Response to reviewers' comments on "Observation and analysis of speciated atmospheric mercury in Shangri-la, Tibetan Plateau, China" by Zhang et al.

Anonymous Referee #1

Fig.2: The denuder-based sampling unit.

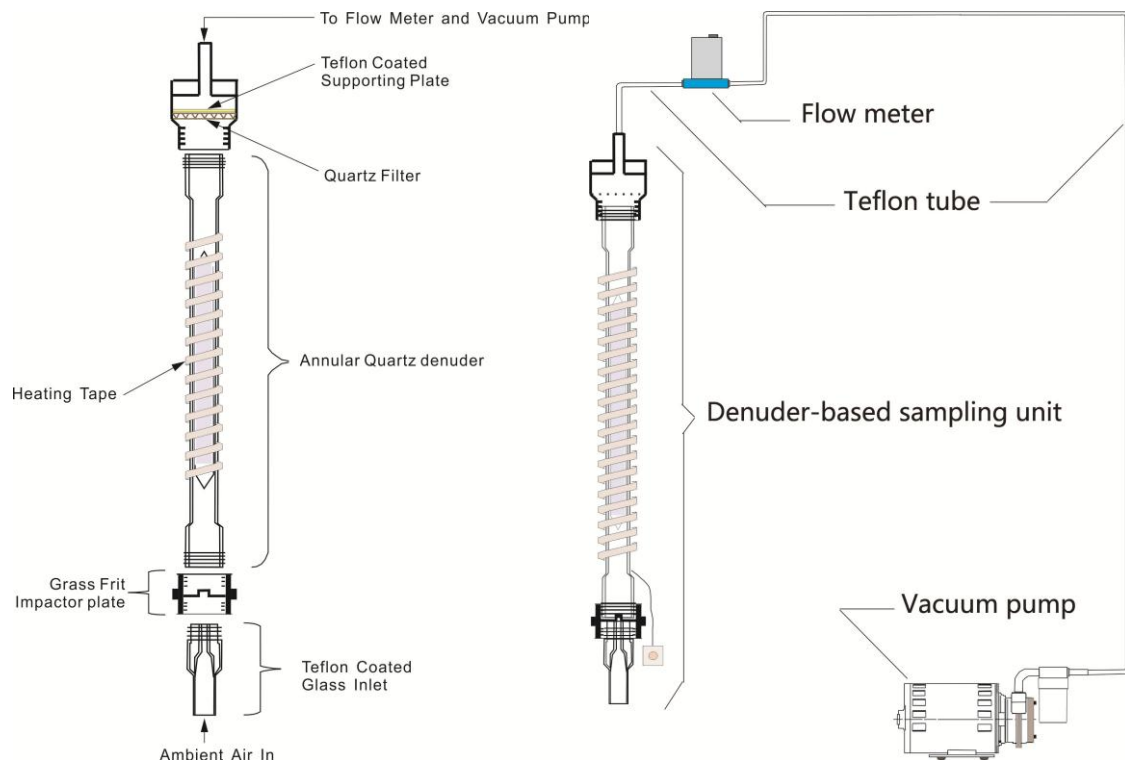
The Tekran speciation units have been used and tested extensively and much information exists on their design and performance. I need to see a diagram or a picture of the system used in this study, the description makes no sense to me. “An unused KCl-coated denuder was also installed in a separate sampling line with an impactor.” So do this mean there were three sample trains? One for “TGM”, one for GOM, and one for PBM?

Response: The manual denuder-based sampling system is analogous to the one used in the Tekran speciation unit. As shown in Fig. 2, the denuder, the inlet and impactor was the identical to Tekran speciation unit, and the temperature conditioner can keep a 40-50 °C for denuder during the sampling period via the heating tape. And the flow meter and vacuum pump was connected to the outlet of denuder, therefore we could get the total volume of sample gas in the two-hours sampling period. Fig. 3 shows the installation of denuder-based sampling unit at the site. Fine particulate ($<2.5 \mu\text{m}$) mercury samples were collected onto the filters. And the GOM and PBM were collected simultaneously during sampling cycle via denuder-based sampling unit. TGM is continuously measured Tekran 2537 except when collected GOM/PGM are being measured. This procedure is identical to the sampling and measurement cycle as the Tekran speciation unit.

Fig 4: The diagram of GOM and PBM analysis

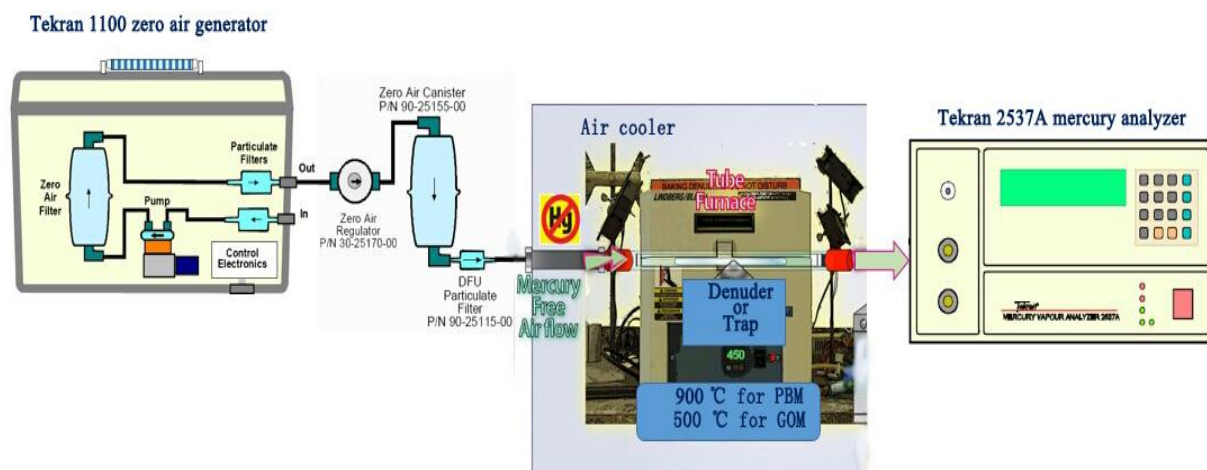
I have serious concerns about the measurement concepts. These concerns originate from the indication on Page 5 Line 11 that “Analytical procedures for PBM and GOM described by Landis et al. were followed.” The issue is that there are two Landis et al papers cited (2002a and 2002b) and neither of those papers has the procedure described here for analyzing filters for PBM. Landis et al.

2002b discusses using 47mm quartz filters, but these filters are microwave digested in HNO₃ and analyzed as a liquid sample. Is that what was done here (no it looks like heat only was used)? If not how were the filters handled? Were they heated in the Teflon holders (I hope not)? The statement “the trap and denuders were rapidly heated to 900 and 500 °C using a pyrolyzer for three heating cycles to convert PBM and GOM into Hg0...” (And several other in this paragraph on Page 5) is directly out of a paper that has used a Tekran speciation unit and does not apply here. A pyrolyzer in a Tekran speciation system is a specific piece of quartz chip filled glass heated to 800 °C to ensure there is no deposition as the sample moves through the sample train. I suspect that is not what was used here.

Response: We appreciate the reviewer’s insight and would like to clarify the measurement approach that we used for GOM and PBM. We cited J. Munthe et al. 2001, Mary M. Lynam et al. 2002, Landis et al. (2002a) to describe the apparatus for the sampling of GOM and PBM. Indeed, Landis’s paper has not described the procedure of PBM analysis, but in J. Munthe and Mary M. Lynam’s papers, the procedure of PBM analysis was described, the difference is that Mary M. Lynam used the nitrogen to carry mercury to 2537A, here we used zero gas to carry mercury to 2537A. Our procedure is identical to Tekran speciation system. Microwave digestion was NOT carried out. Instead, as shown in Fig.4 and Fig 5, a denuder from URG Corporation was used for the GOM sampling (Fig. 6). A separate PBM quartz trap of identical connector was used for PBM sampling. The detection of PBM signals was achieved using the paralyzer at 900 °C. During the heating, the Teflon holder was NOT heated. We recognize that Tekran uses quartz chip to prevent mercury deposition in the Regenerable Particulate Filter (RPF) Assembly in the 1135 unit. In our manual method, the Teflon line from the trap to the inlet of Tekran 2537A (Fig. 4) was short (~1 m) and therefore the mercury deposition in the Teflon line is negligible. We have added the description in revised paper (P5, L19-28).

Fig 4: The diagram of GOM and PBM analysis

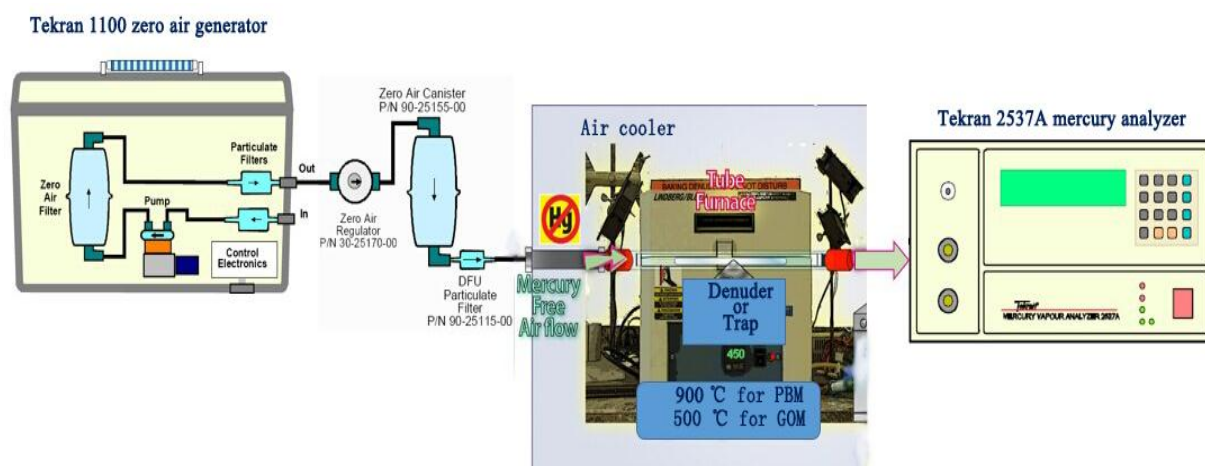
I have personally, manually sampled ambient air with denuders to be analyzed for GOM concentrations. This task is not trivial. What style of denuders were used? What filters were used? These are questions that I asked in my original review that were completely ignored by the authors. Were the denuders heated in a tube or clamshell furnace? If so what end caps were used? My own experience has shown me that the end caps can heat up during the heating in a furnace and can liberate Hg from the end caps. How was this prevented?

Response: As discussed in our earlier response, we used the identical denuder in Tekran speciation system. We used the Whatman Grade QM-H Quartz Filter for sampling PBM (http://www.gelifesciences.com/webapp/wcs/stores/servlet/catalog/zh/GELifeSciences/products/AlternativeProductStructure_21531/28418567). As shown in Fig. 4, the denuders and traps are heated in the furnace that fits the size of denuder. The end caps were the URG plastic caps (Fig. 5) and not heated during the analysis. In addition, air-cooler was used for decreasing the temperature of caps. We have added the description in revised paper (P5, L25).

Fig.2: The denuder-based sampling unit.

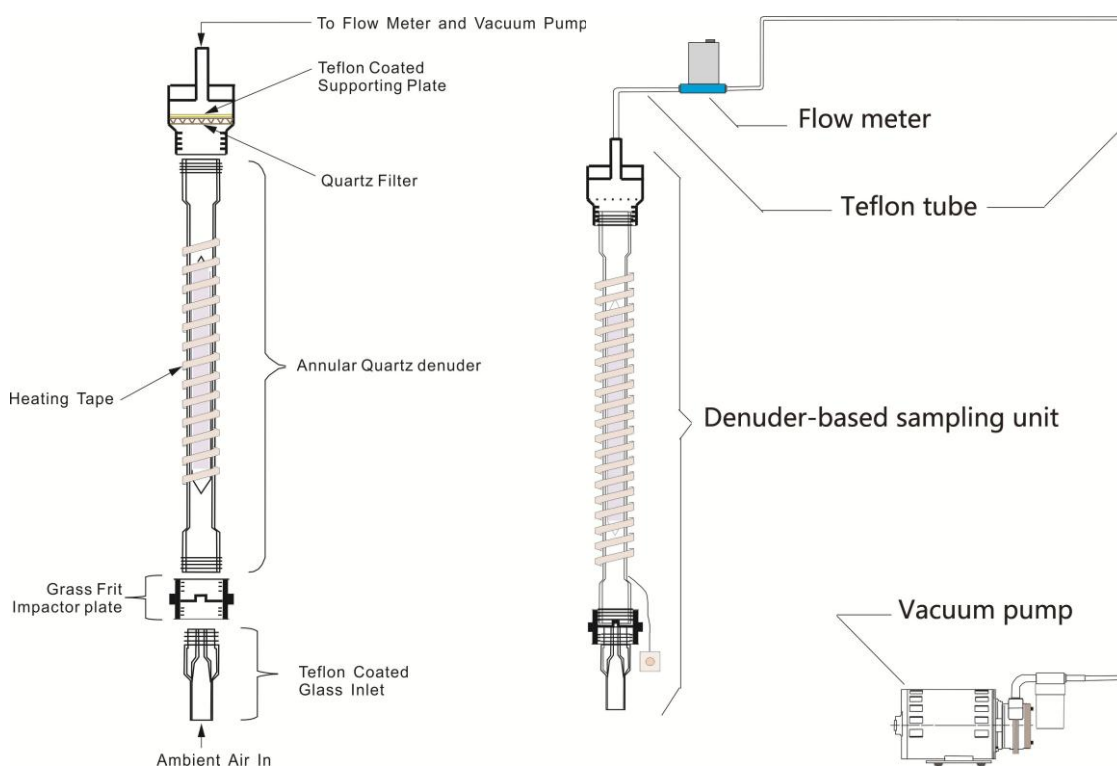
3. The description of sampling instrument is not very clear. I think the authors should prepare a figure or diagram showing how the manual GOM and PBM sampler was connected to the Tekran 2537A. Was the TGM measurement continued when analyzing the GOM and PBM samples?

Response: We agree with the reviewer that a figure helps illustrates the sampling scheme. As displayed in Fig.2 and Fig.3, the denuder, inlet and impactor was identical to Tekran speciation unit, and the temperature conditioner keep the denuder at 40-50 °C during the sampling period. The quartz filter was also of the same specification as the filter used in Tekran speciation unit, except with a larger diameter (47mm). The GOM and PBM were collected simultaneously during sampling cycle using two parallel denuder-based sampling units (Fig. 2 and Fig. 3). Since this is an off-line analysis system, the Tekran 2537 did not connected to the sampling unit (Fig. 4 and Fig. 5) and the TGM was continuously measured except during the analytical cycles of GOM and PBM.
